STATION HILL READING

AMENDMENTS TO RMA REF:
190465 PLOT E

JUNE 2020

This document sets out the changes in the approved plans to application ref: 190465 following the design development of the scheme since March 2019.

1 Block E - Lower Ground Floor Level
1: 250

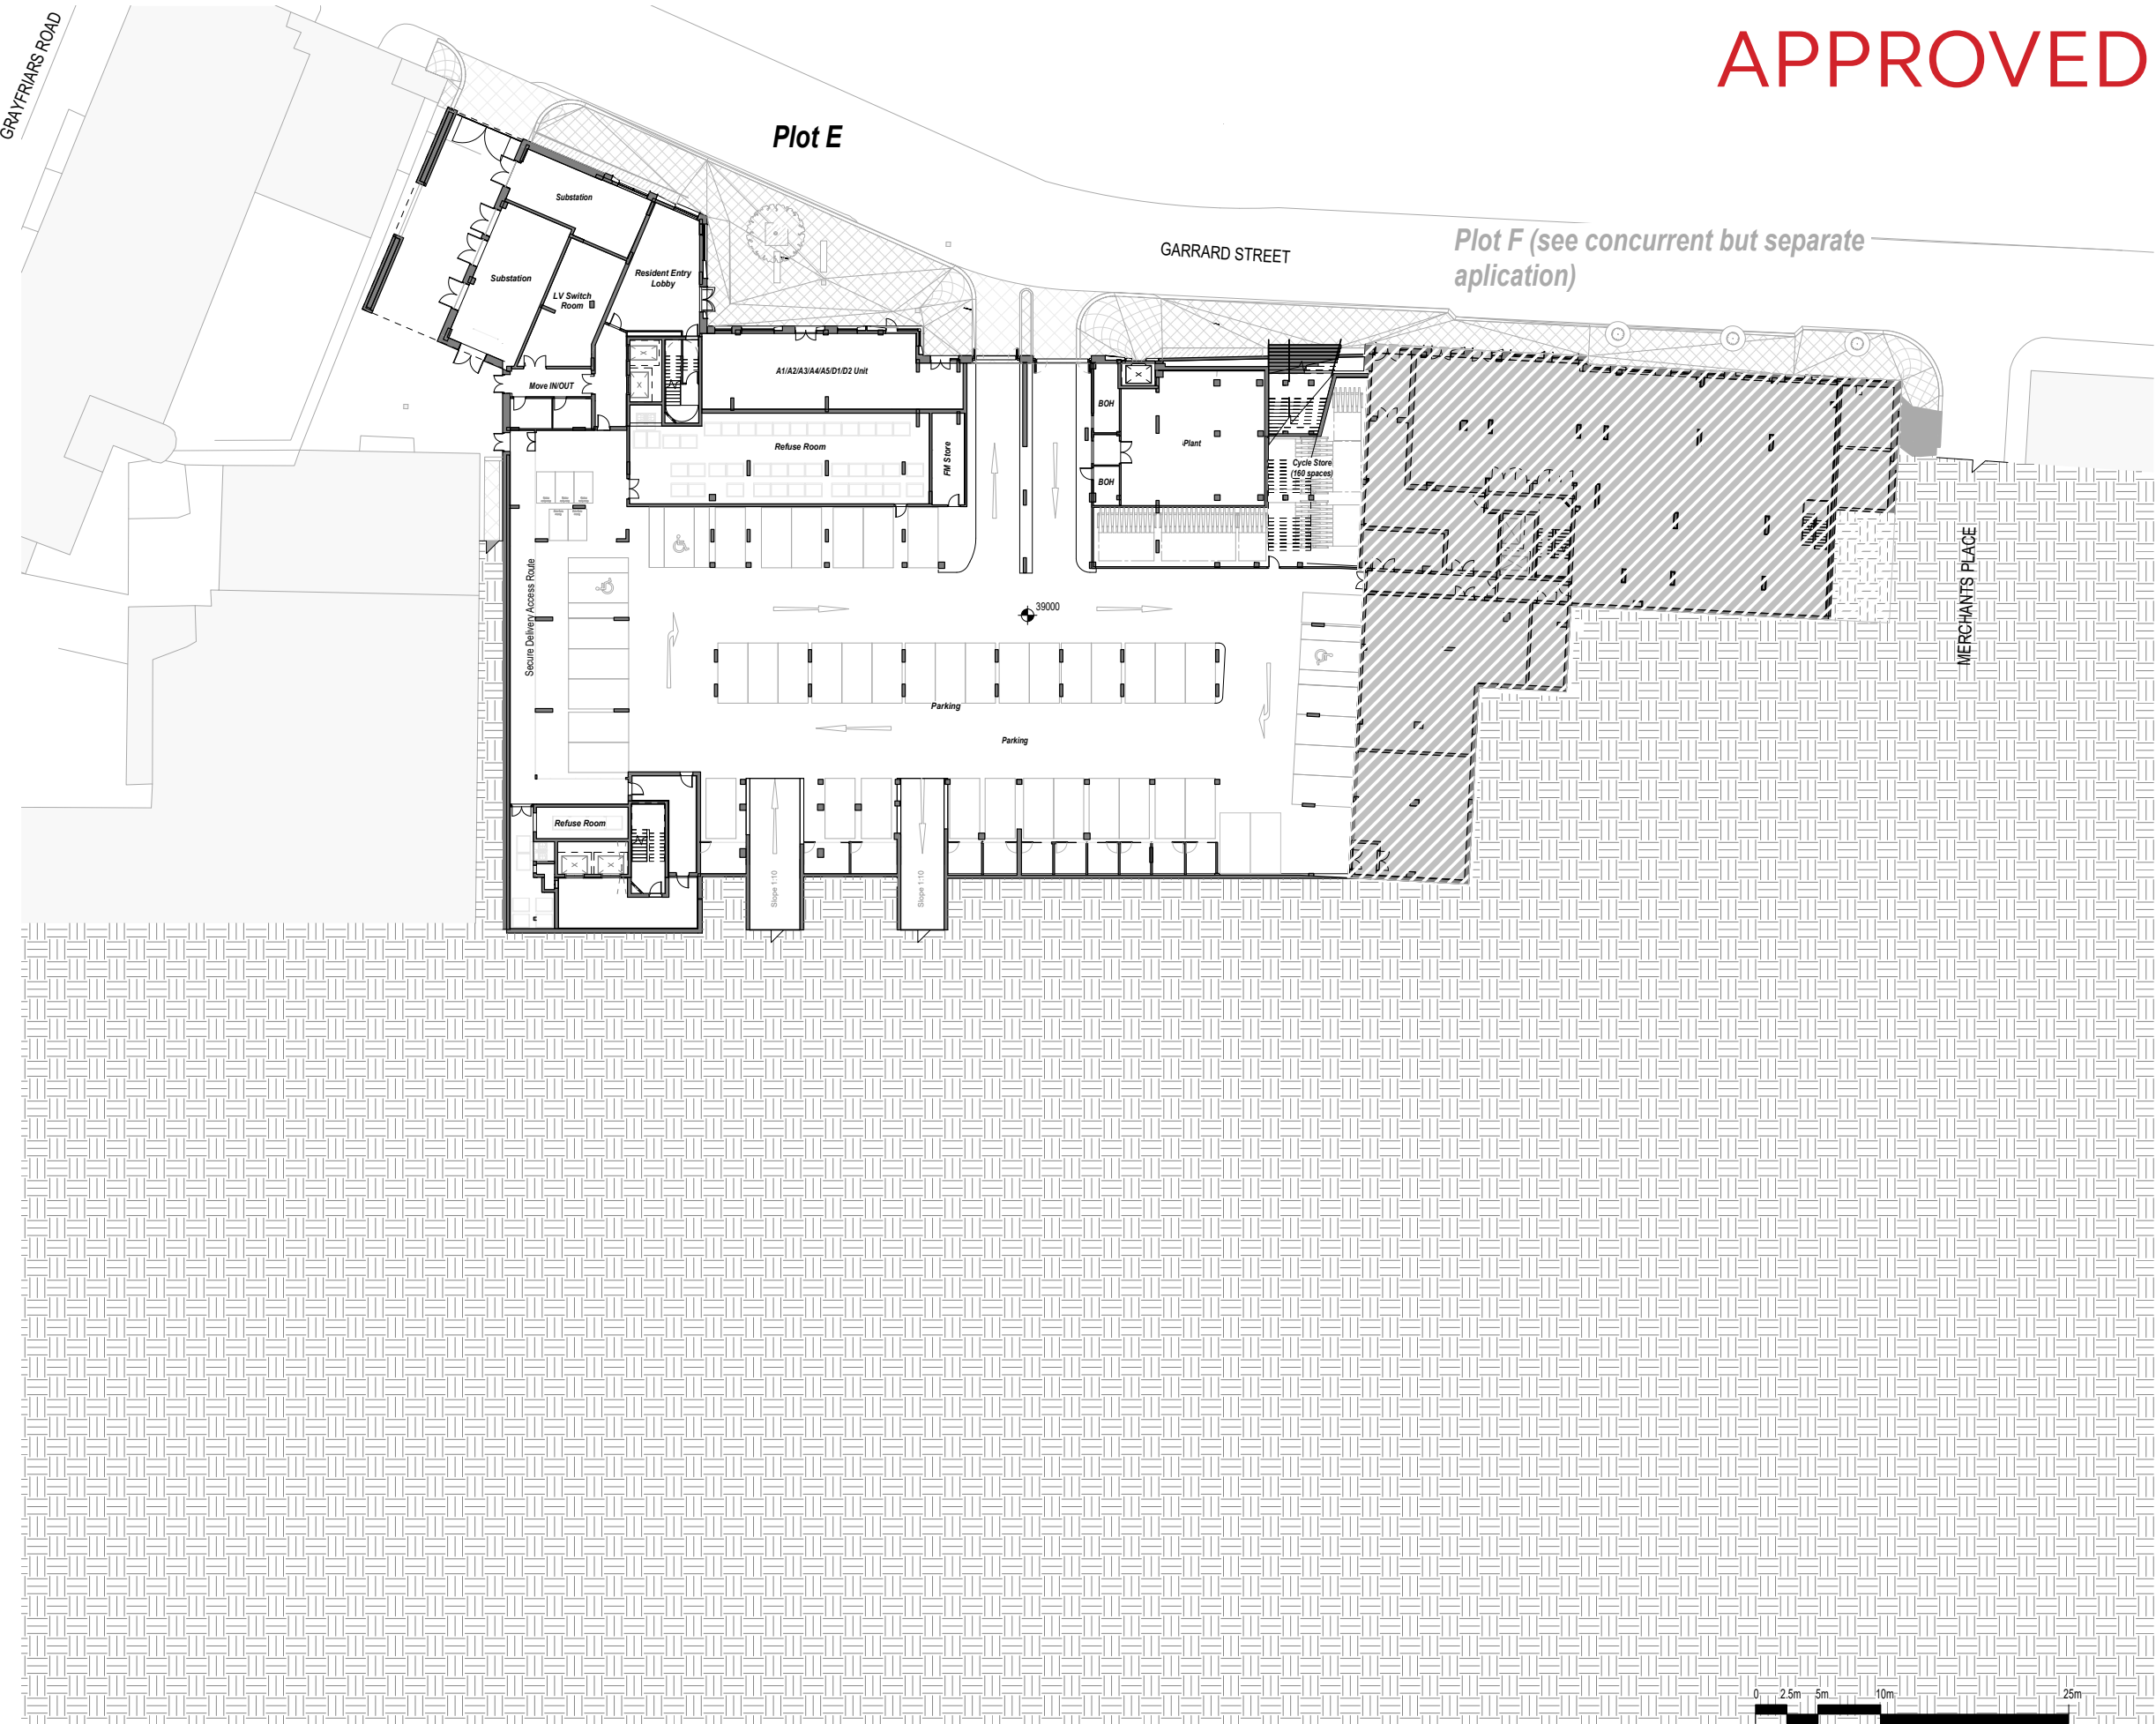
Staircase omitted, plant room and cycle store layouts adjusted to suit, with no change to cycle numbers. Car parking layouts adjusted to suit revised layout with no change to parking numbers.

Car wash area, 2no. parking spaces relocated to near the bicycle store.

**Plot E - Ground Floor
Level (45.7 AOD)**

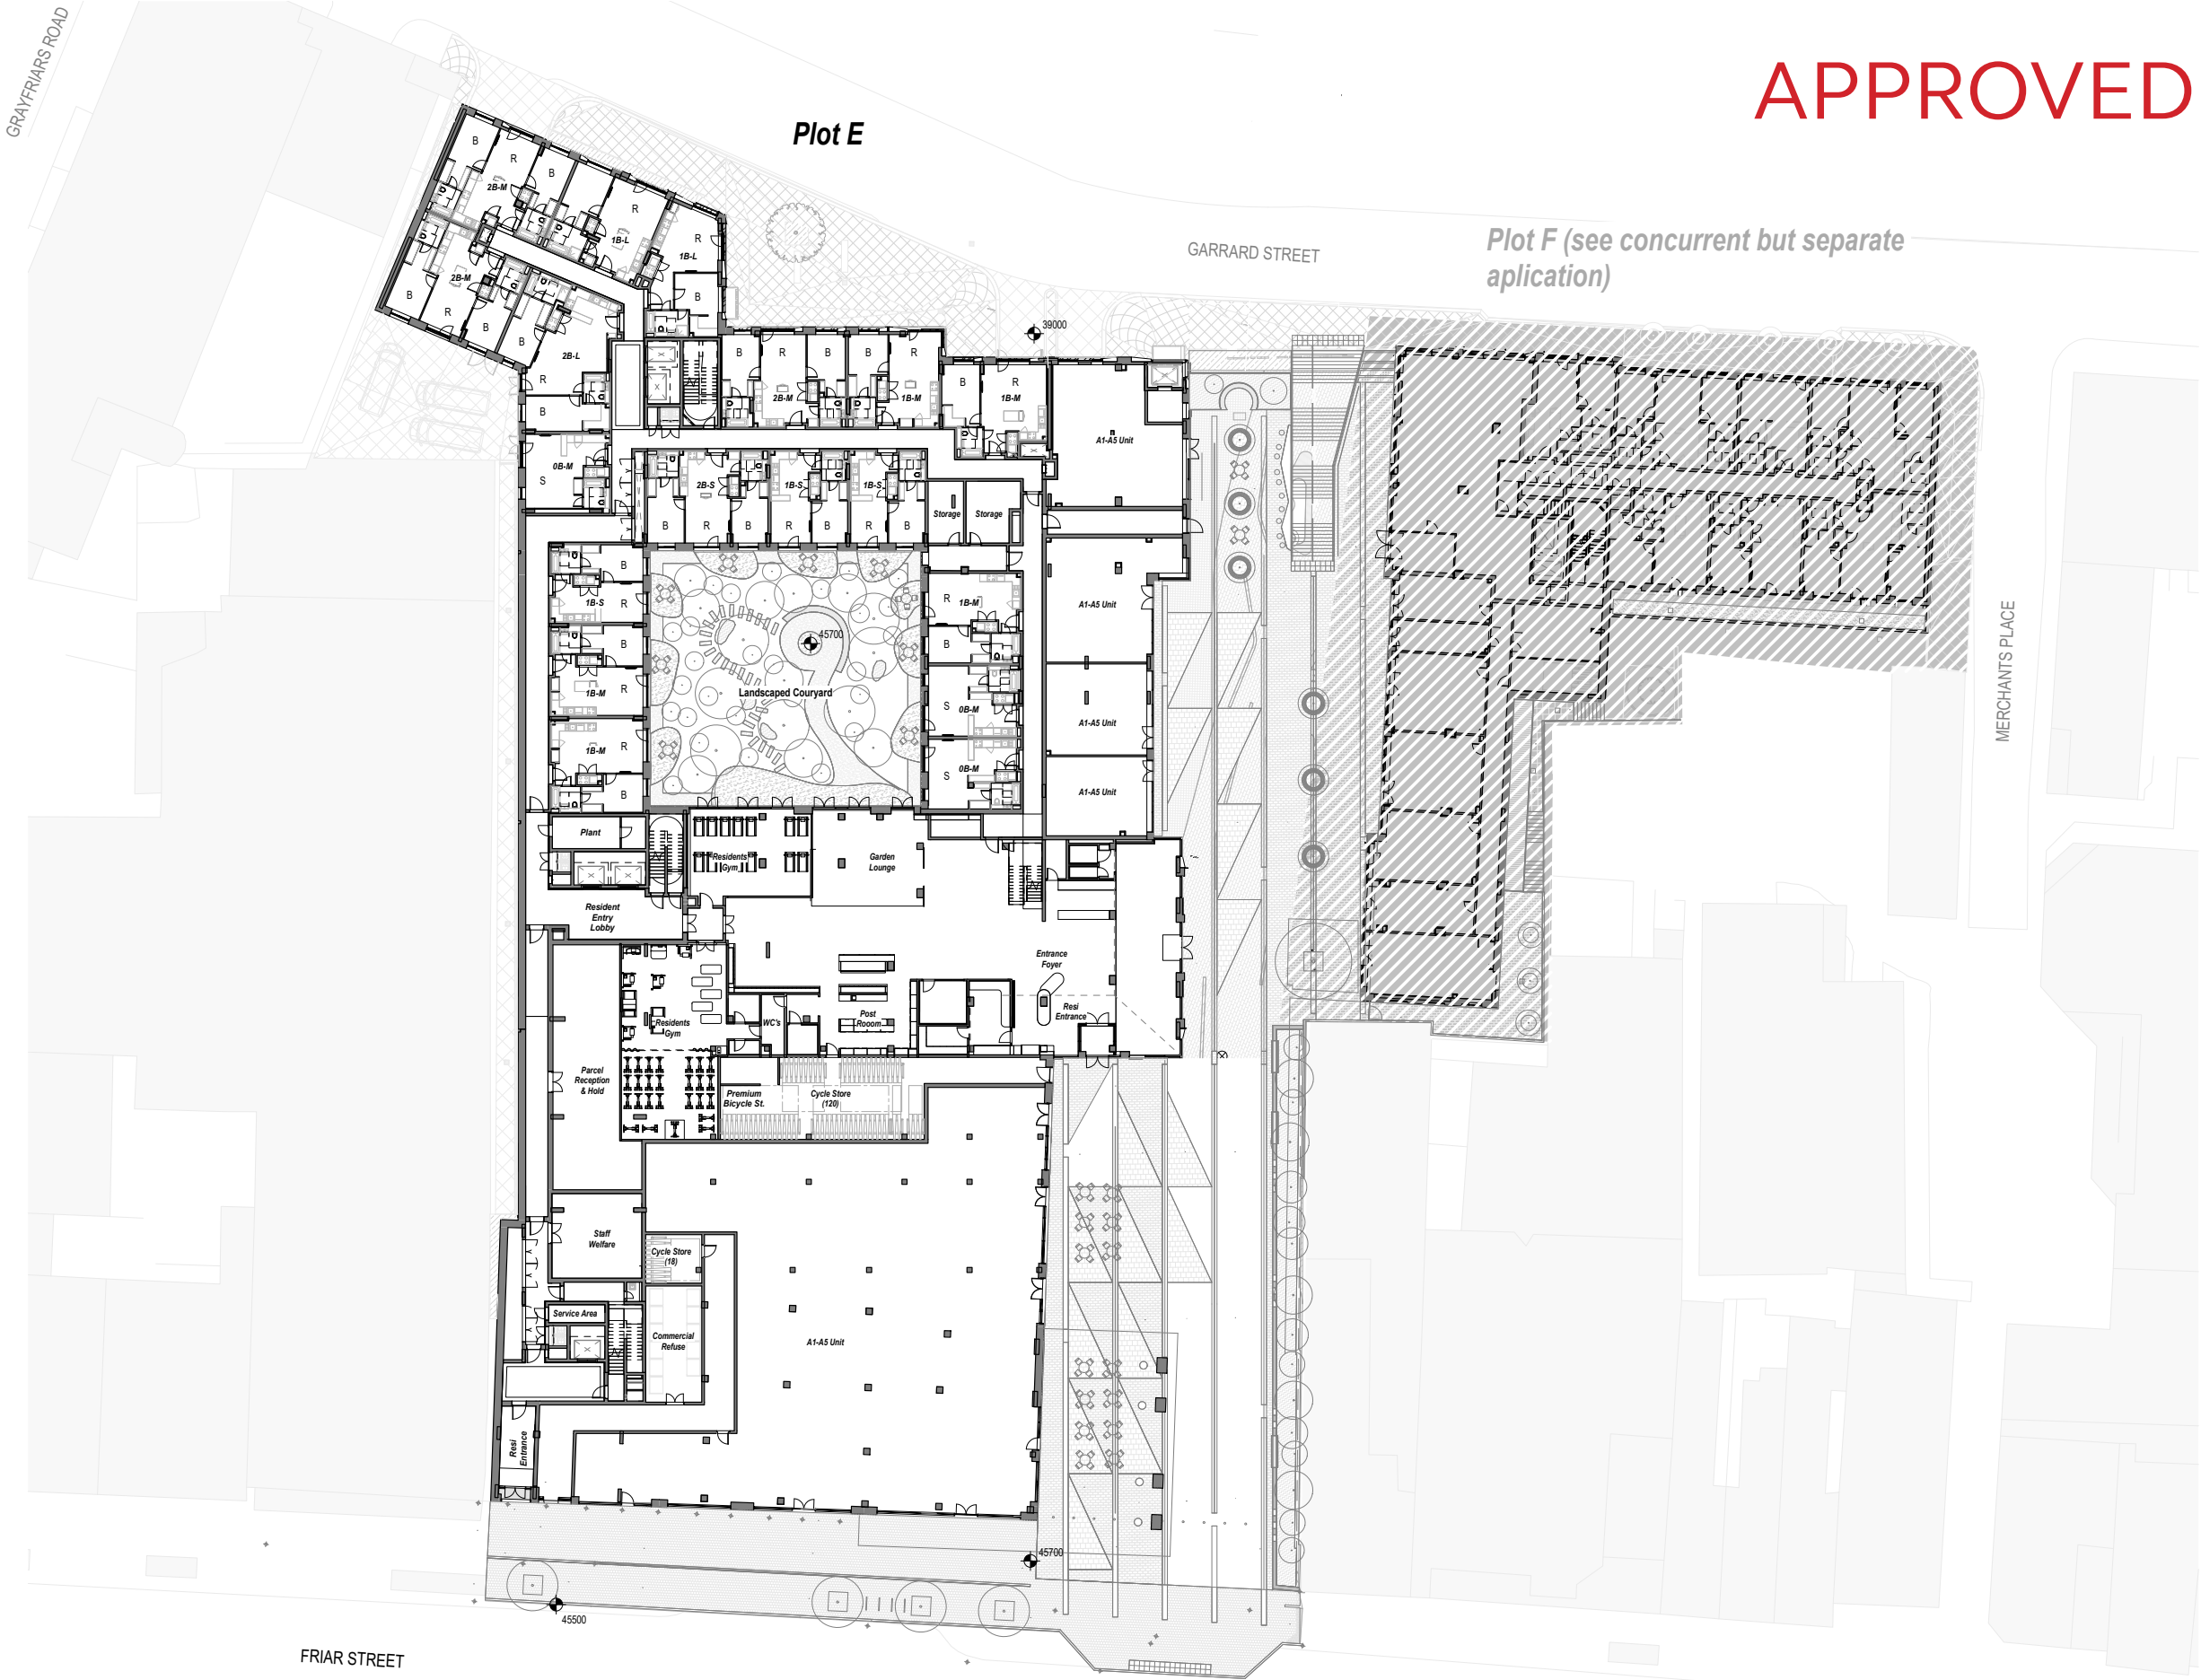
Indicative location of
Phase 2 bridge.

Revised landscape proposal
to the north courtyard. Refer to
Section 5 for details.

Staircase omitted, landscape
adjusted. Revised landscape proposal
to Friars Walk. Refer to Section 5 for
details.

Revised landscape proposal
to Friars Walk. Refer to
Section 5 for details.
